# TOYOTA

## SERVICE BULLETIN

REFERENCE	<u>TRANSMISSION &amp; CLUTCH</u>
NUMBER	<u>042</u>
DATE	<u>12-21-90</u>
MODEL	<u>ST, AT, SW, VV,</u> <u>SV, AC</u>

### CLUTCH START SWITCH

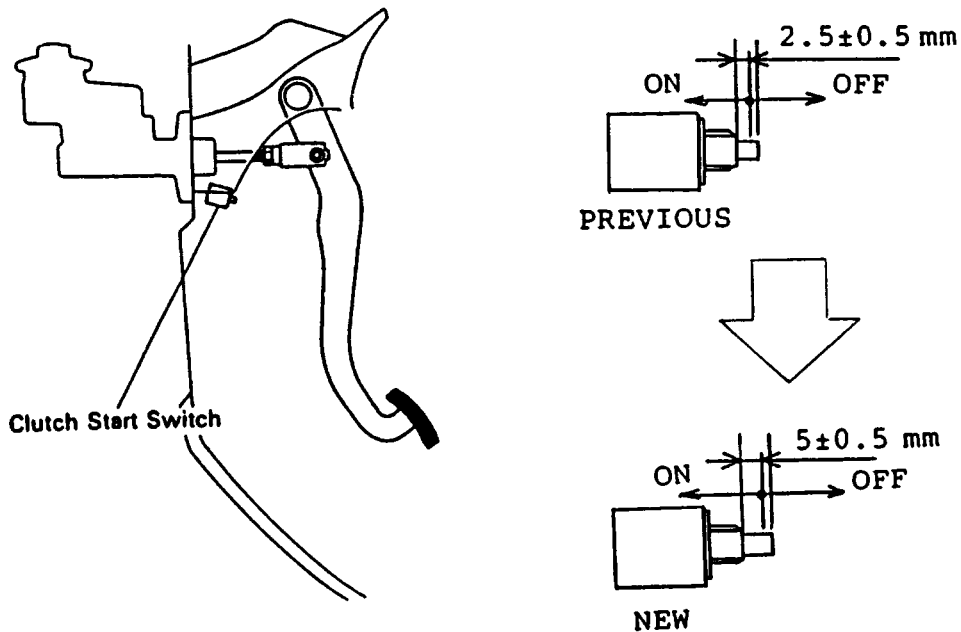
To reduce the length of travel required of the clutch pedal to engage the clutch start switch for engine starting, the clutch start switch has been modified as shown below:

<u>PREV. Part No.</u>	<u>NEW Part No.</u>	<u>Part Name</u>	<u>Models</u>
84520-20010	84520-20020	Switch Assy., Clutch Start	Celica, MR2 Previa
84520-32020	84520-32021	Switch Assy., Clutch Start	Camry (SV, VV)

PARTS ARE INTERCHANGEABLE
